Access Compliance Report

Public Rights-of-Way

(Curb Ramps)

Intersection ID: N/A	Main Street: PROVIDENCE_RD	Cross Street: OUTER_BRIDGE_LN	Location: NE
ADA ID: 6C638B84D6D4	Ramp Type: Perp	Initial Pass/Fail: Fail	Overall Compliance: No
Codes/Mitigation Info/Possible Solution		Field Measurements/Component Compliance	
Severity Score: 21.25

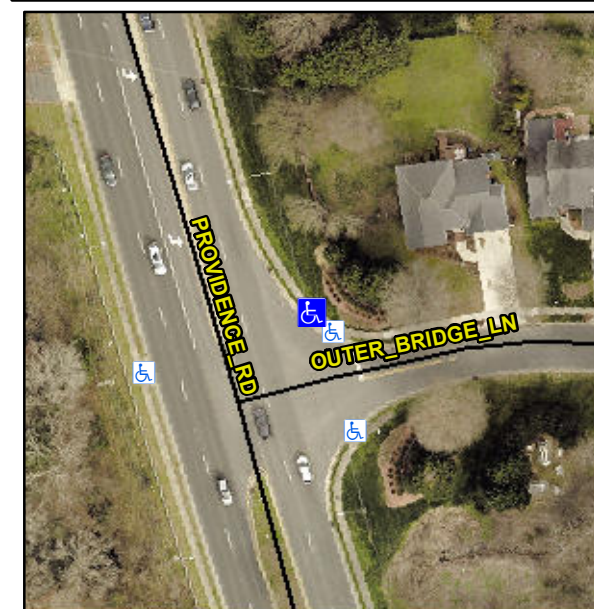
R304.5.1, R304.2.2

Compliance	Description	Data	Compliance	Description	Data
N/A	Ramp Length (in)	72.0	No	Ramp Slope (%)	9.3
No	Ramp Width (in)	45.0	Yes	Ramp XSlope (%)	1.1
N/A	Flare Type LT	N/A	N/A	Flare Type RT	N/A
N/A	Flare Slope LT (%)	N/A	N/A	Flare Slope RT (%)	N/A
N/A	Flare Traversable LT?	N/A	N/A	Flare Traversable RT?	N/A
N/A	Landing Length (in)	N/A	N/A	DWS Provided?	N/A
N/A	Landing Width (in)	N/A	N/A	DWS Contrast?	N/A
N/A	Landing Slope (%)	N/A	N/A	DWS Length (in)	N/A
N/A	Landing X Slope (%)	N/A	N/A	DWS Full Width?	N/A
N/A	Landing Curb? (Y/N)	N/A	N/A	DWS Offset (in)	N/A
N/A	Shared Landing?	N/A			
N/A	Gutter Ponding?	N/A	N/A	Gutter Slope (%)	N/A
N/A	Gutter Lip Ht (in)	N/A	N/A	Gutter X Slope (%)	N/A
N/A	Painted X Walk1?	No	N/A	Painted X Walk2?	N/A
	X Walk 1 Direction	To W		X Walk 2 Direction	N/A
N/A	X Walk 1 Width (in)	N/A	N/A	X Walk 2 Width (in)	N/A
	X Walk 1 Slope (%)	1.3		X Walk 2 Slope (%)	N/A
	X Walk 1 X Slope (%)	0.1		X Walk 2 X Slope (%)	N/A

Remove & Replace Entire Ramp.
